Implications of Finite Equalizer Penalties for TP3 Sensitivity Testing

Comments on the “sieve” method adopted in Vancouver for selecting IPRs for the normative receiver sensitivity test

Robert Lingle, Jr., OFS
Kasyapa Balemarthy, Steve Ralph, GaTech

Minimum Complexity Equalizer for the TP3 Test Pulses

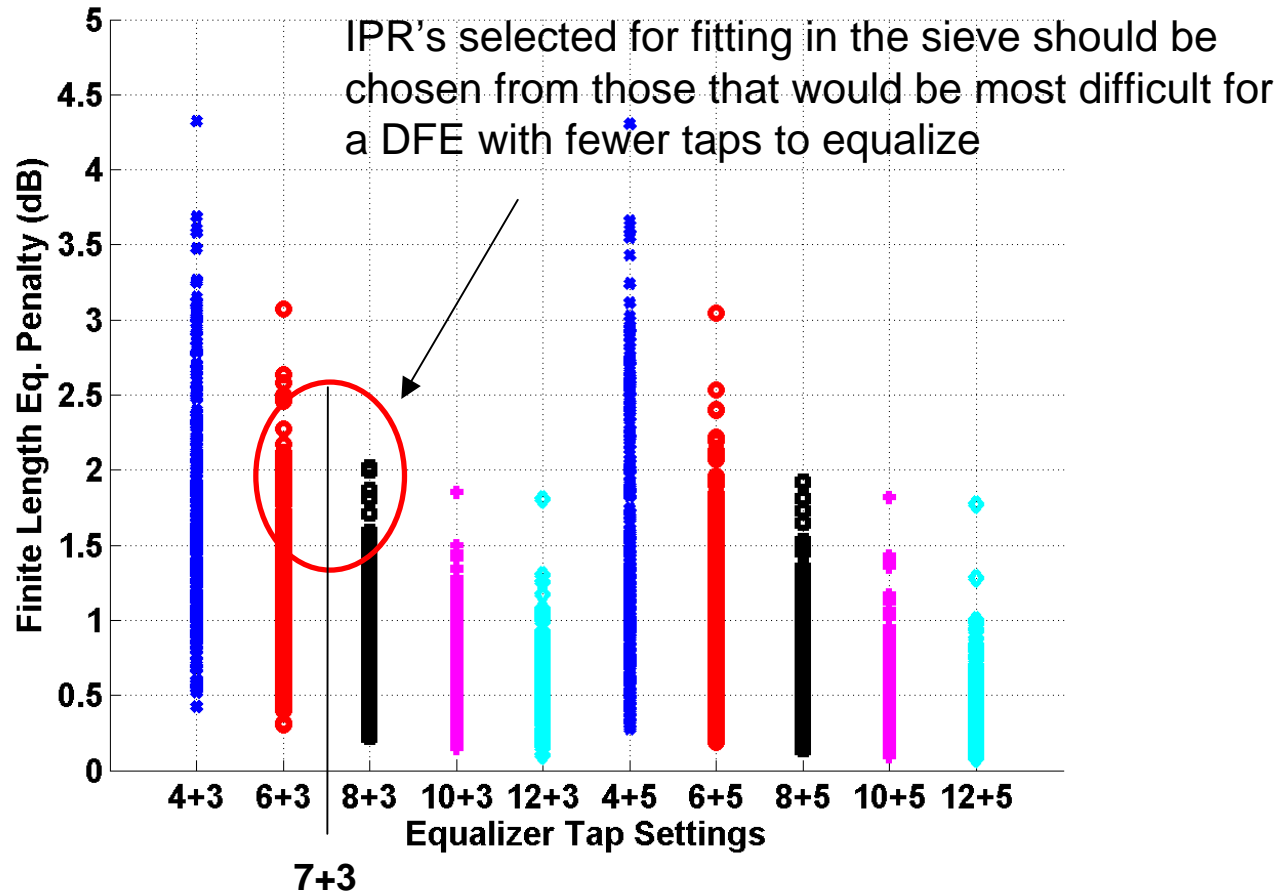
- Fiber F3: pulse with post-cursor ISI, PIE-D curve is green dashed, horizontal line
- Minimum complexity finite-length DFEs that satisfies total penalty < 6.0dBo (see left panel) for TP3 test impulse responses:

- Allocates 0.5 dB to hardware penalty alone, leaving 1.5dB for finite length effects
 - **7 FF taps (T/2-spaced) + 3 FB taps** (interpolated) (has a ~0.1dB margin from 6.0dBo)

- **9 FF taps (T/2-spaced) + 2 FB taps** (interpolated) (has a ~0.1dB margin from 6.0dBo)
- Note that the finite-length portion of the implementation penalty (y-axis of right panel) for these configurations is approx. 1dB for fiber F1 for the minimum complexity equalizers (interpolating for odd # of FF taps) and approx. 0.5dB for F2 and F3

Select only IPR's from 1998 fiber set for which
 $4.5\text{dB} \leq \text{PIE-D} \leq 5.0\text{dB}$

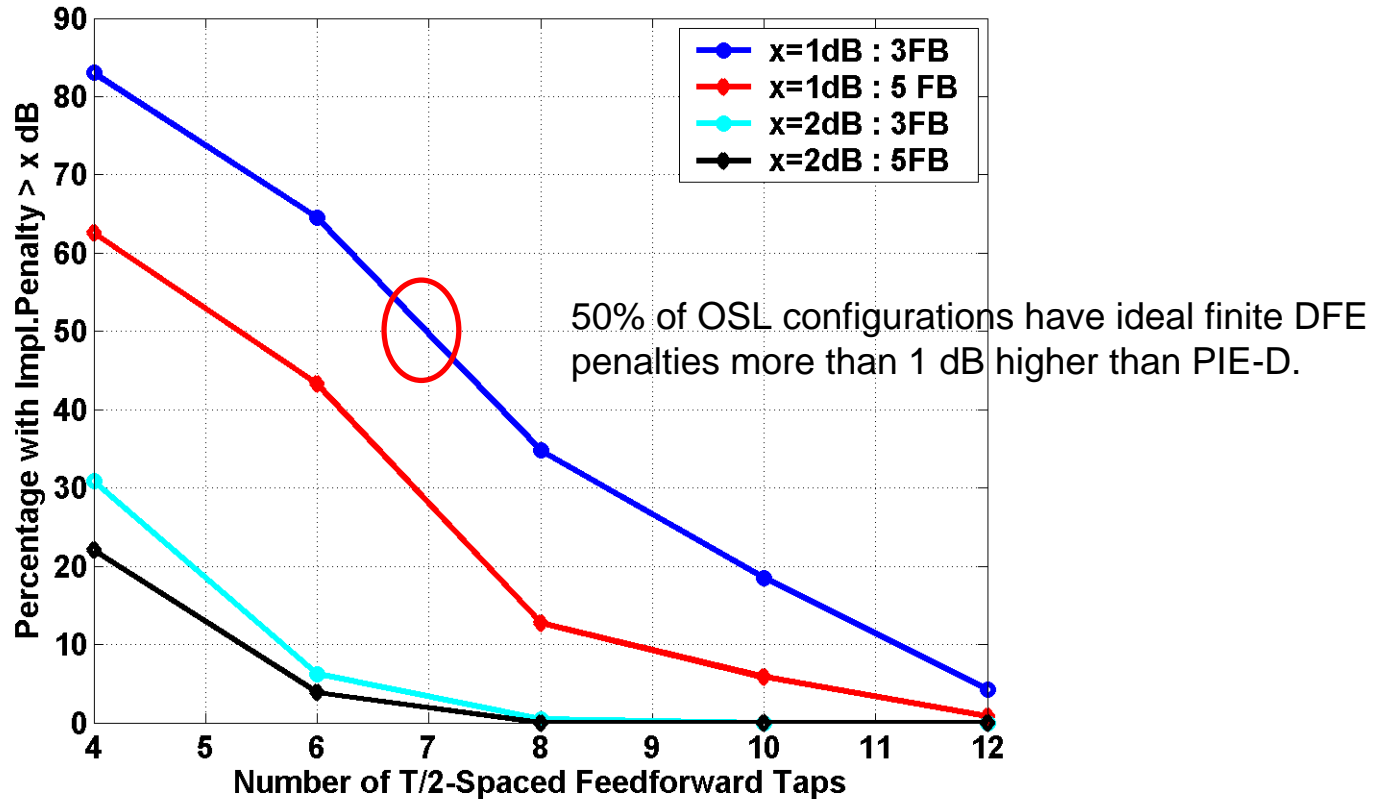
Implementation Penalty Due to Finite-Length
= Ideal, Finite DFE Power Penalty – PIE-D

- For a shorter DFE, such as the $7(T/2)+3$ minimum complexity equalizer for TP3 test impulses (slide 5), it is possible for the finite DFE power penalty to exceed PIE-D by 2dB or more, *prior* to considering the hardware implementation penalty.
- Ranking IPRs for TP3 testing by PIE-D alone will not sufficiently test short DFEs
- In fact a $7(T/2)+3$ DFE would succeed on the TP3 IPRs, while failing on a number of the IPRs represented above. This eventuality should be prevented.
